**DEPARTMENT OF PLANNING AND COMMUNITY DEVELOPMENT
CONTINUATION OF DESIGN RESPONSE CONFERENCE**

File No.: DRC09-00003
Project Name: Hector's Expansion
Applicant: Rick Chesmore, Chesmore/Buck Architecture
Project Planner: Jon Regala, Senior Planner
Date: October 19, 2009
Meeting Date and Place: 7:00 pm, Monday, October 19, 2009
City Hall Council Chambers
123 5th Avenue, Kirkland

SITE PLAN

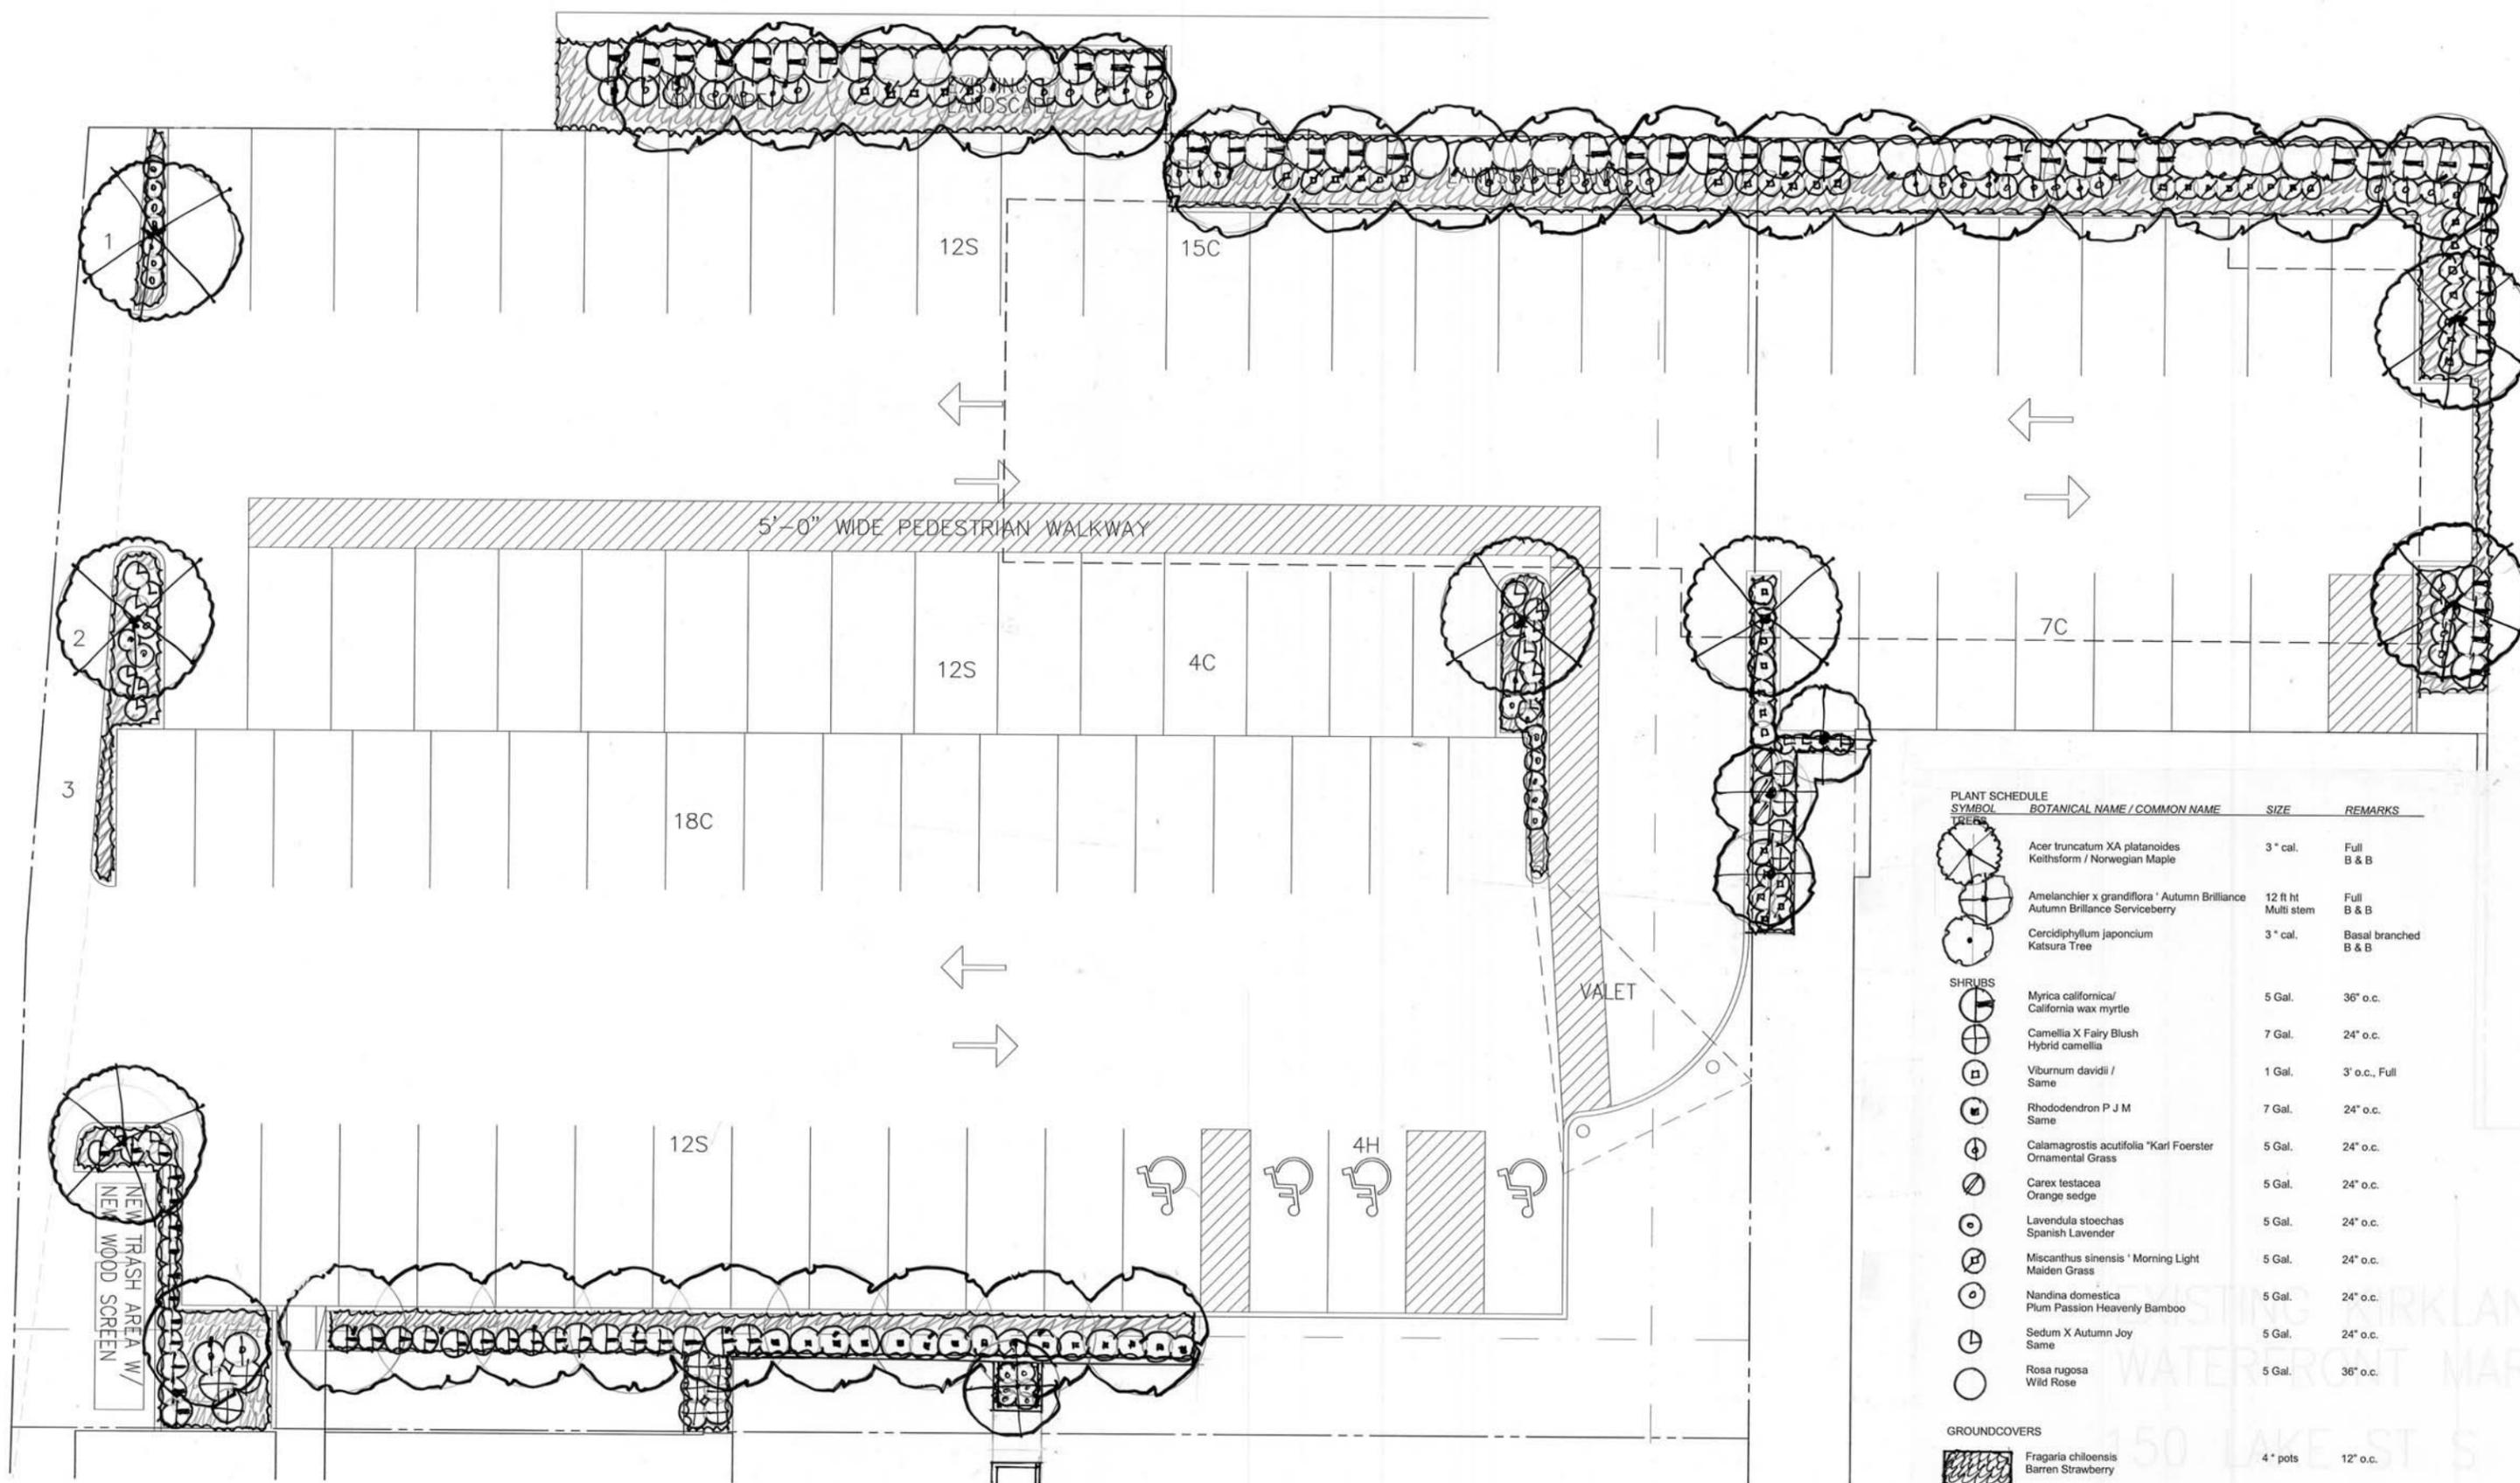
- H. *Provide details of Lake Street South frontage improvements to include future location of outdoor dining areas/fencing.*

Staff Response: Attachment 2, Sheet 1.2 shows the applicants response to this item. The Kirkland Municipal Code Section 19.04 allows sidewalk cafes provided a minimum 6' unobstructed pedestrian corridor is retained. The DRB should review the information provided based on the following design guideline.
